Scientific/Detailed Comments: Referee comments in bold and author answer non-bold.

Review comments by Referee #1

Figure 1: Components of TSMP CLM5+PDAF highlighting the distinct separation of PDAF functionality, TSMP driver and wrapper, and CLM5 pseudo-library. Modifications are in relation to the implementation by Kurtz et al. (2016).

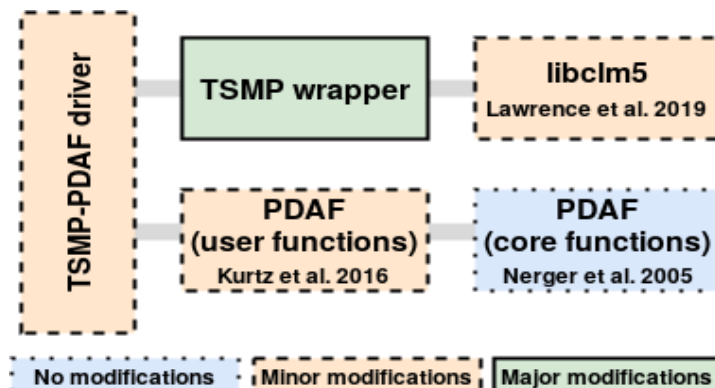
Ln 181: The “Figure 1” is not helpful, either improve or remove. Also, rephrase and elaborate the discussion.

We use Figure 1 as a visual aid to describe the structure of both the actual implementation and the paragraphs in the section. We improved the figure by adding more information and elaborated the discussion.

“Figure 1 sketches the organization of the CLM5-PDAF coupling into five main components. The next paragraphs describe these components in more detail and modifications compared to the CLM3.5-PDAF implementation by Kurtz et al. (2016) are discussed.”

Figure 2: Schematic overview of CLM5 ensemble mode (left side) and CLM5+PDAF (right side) communication initialization and process flow. The schema highlights the addition of communication for all ensemble members through the PDAF communication model.

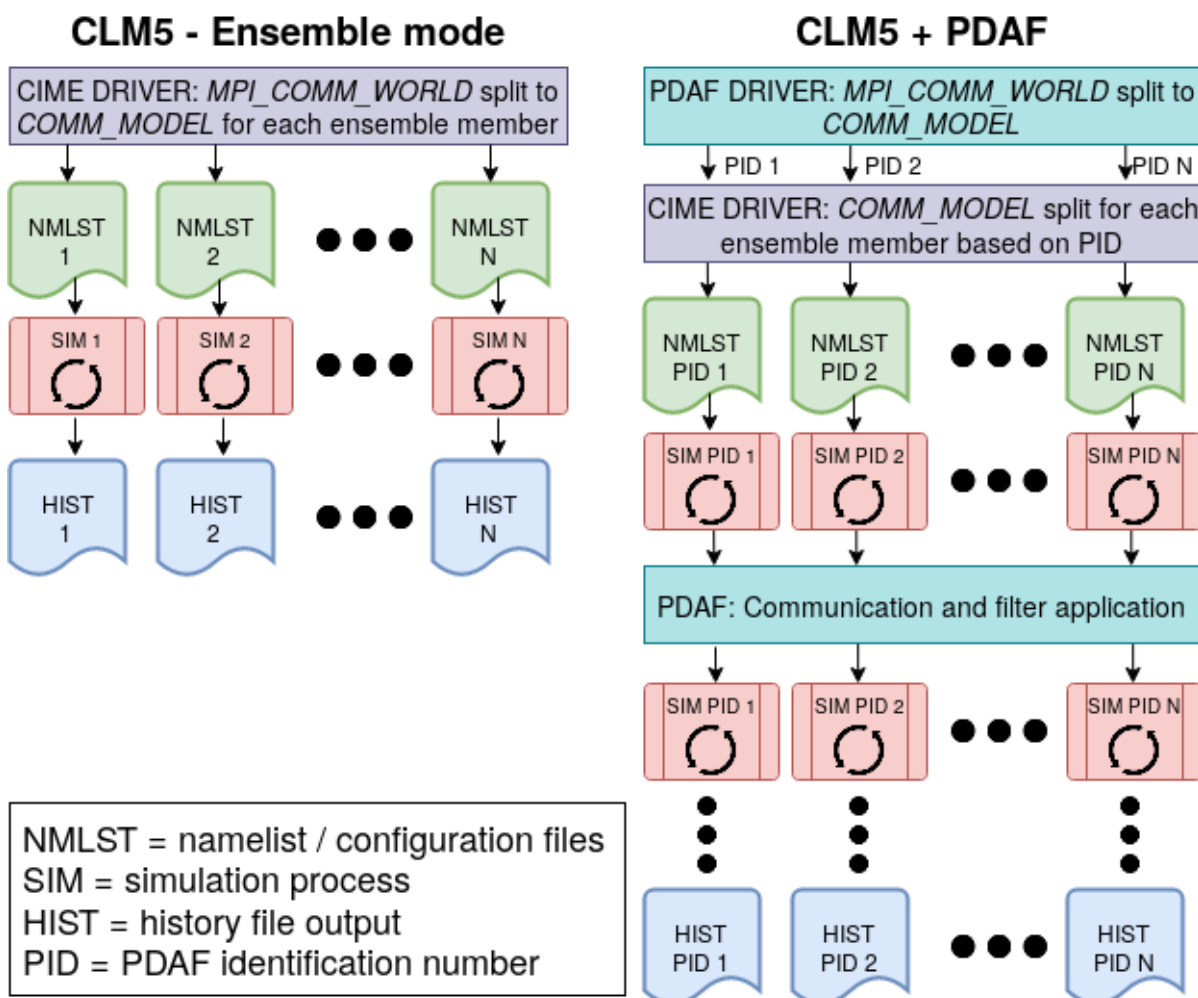
Figure 2: “In the diagram NMLST means namelist, SIM means simulation process, HIST means history file output, PID means PDAF identification number.” – this should as legend in Figure.

We added a legend with the shorthand.
